2016 - 2017 Cadillac CTS-V: GM TechLink: Fuel Line Pulsation Sound

GM TechLink

FIG. 9

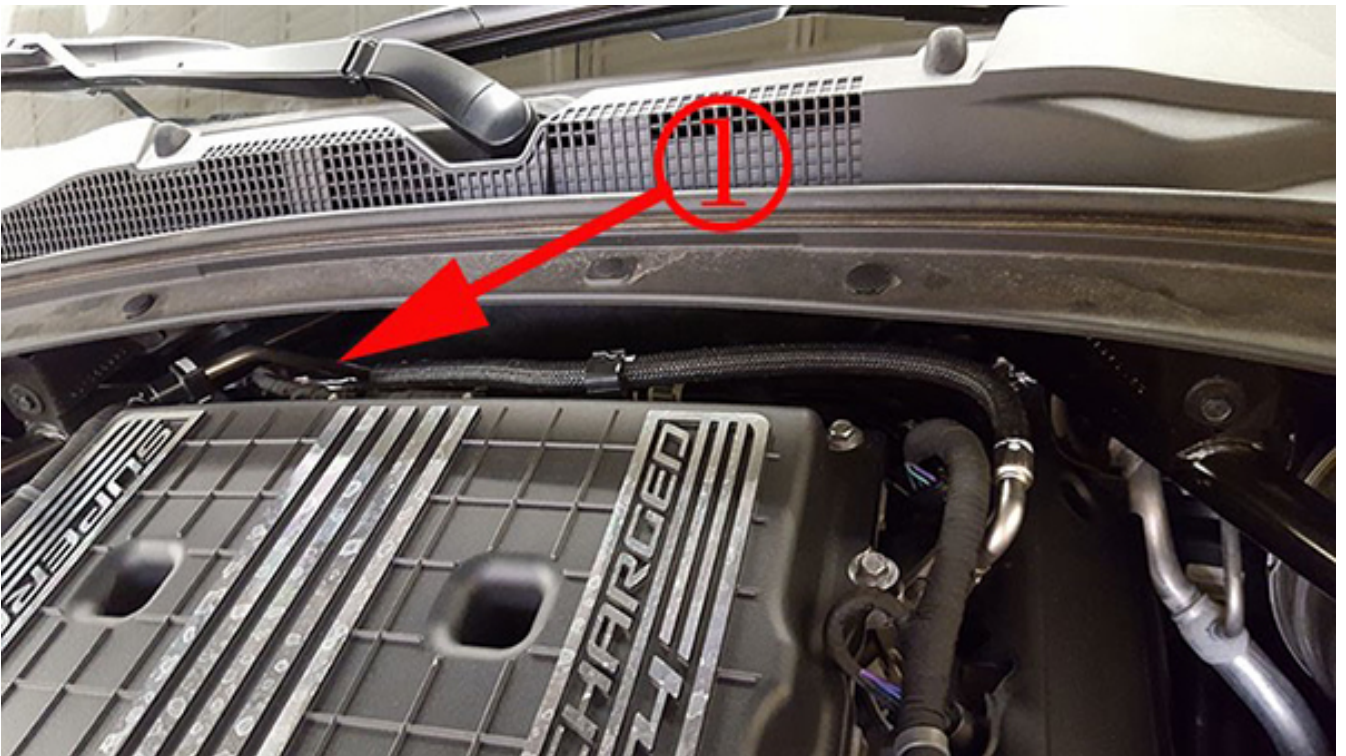
Listen to the fuel line connection at the left side of the engine. The fuel feed line between the high pressure fuel pump and chassis fuel line may be allowing high pressure pulsation back to the low side of the fuel system. If the sound is heard, the line will need to be replaced. On some trucks and SUVs, a vibration also may be observed in the fuel line at the fuel tank.

There are two different types of fuel lines that contain a check valve. The lines vary by model. Only one line should be used on Corvette, truck and SUV models. (Fig. 9) The line connects the chassis fuel line to the high pressure fuel pump. (Fig. 10)
